Consultation Response from KC, Highways Development Management
2026/91969 land off, Fenay Lane, Almondbury, Huddersfield, HD5 8UJ
Erection of 6 dwellings, with associated access, landscaping, infrastructure and works
Date Responded: 11 August 2026 Responding Officer: Sheila Henley Responding Ref: K11-6SW/2

Recommendation: Further Details and Revisions.

Plan ref: (PL)123C - Hard Landscape; 26-255-EW07-P01 - Hard Surfacing; 26-255-EW03-P02 - Vehicle Tracking

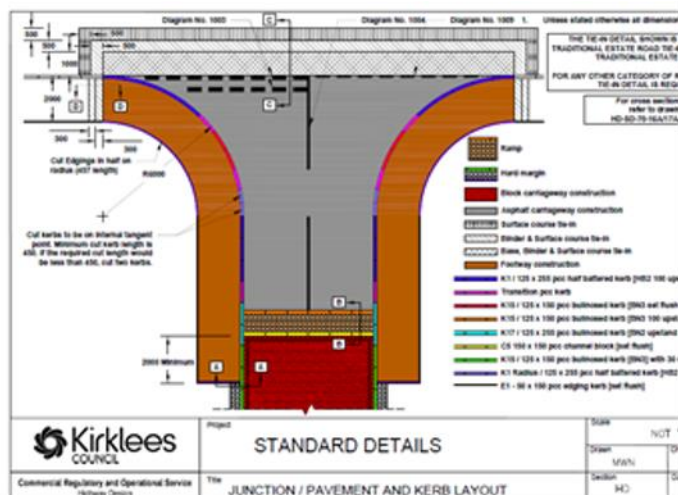
Access: The proposal shows the creation of a new all-purpose residential access junction from Fenay Lane with 6.0m approach width, 6.0m radii with 2.0m footway surrounds connecting to the existing footway on removal of the boundary wall. Visibility splays of 2.4 x 43m are to be provided in each direction compliant with a 30mph speed limit.

The junction will need to be amended to accord with the Kirklees specification as shown below despite the swept paths being mostly acceptable other than for the left turn out which is too tight to the kerb line and adjustment will be necessary.

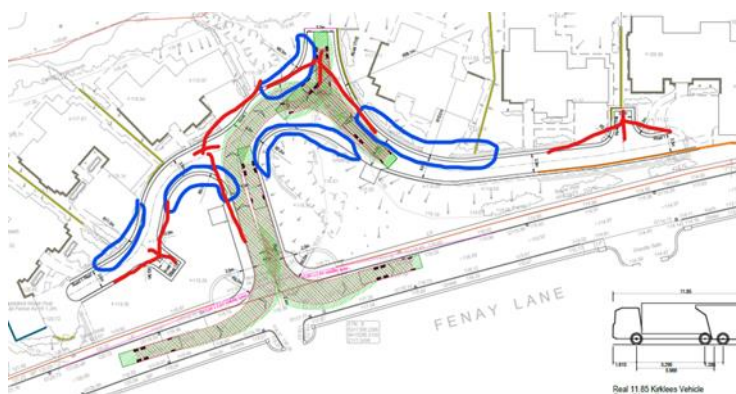
There are no visibility splays indicated. Junction and Forward Visibility Splays and dimensions must be in accordance with the KHDG SPD Table 1 with junction visibility 2.4m x 25m (circled red) and forward visibility around the bends of 25 metres (circled blue). Junction visibility splays apply to the turning heads too if the extents of the carriageway are less than 25.0m. There must be no obstructions within these areas i.e. street furniture, parking bays, landscaping etc.

For waste collection, there is space for bin storage. The submitted swept path demonstrate that the vehicle can access and turn within the initial 'Y' section of the street. Yet, the bin pull distances to the collection points exceed 30m for the proposed dwellings at the extremes and should be reviewed and if necessary, the streets widened as circled below for the waste collection vehicle to reach these plots:
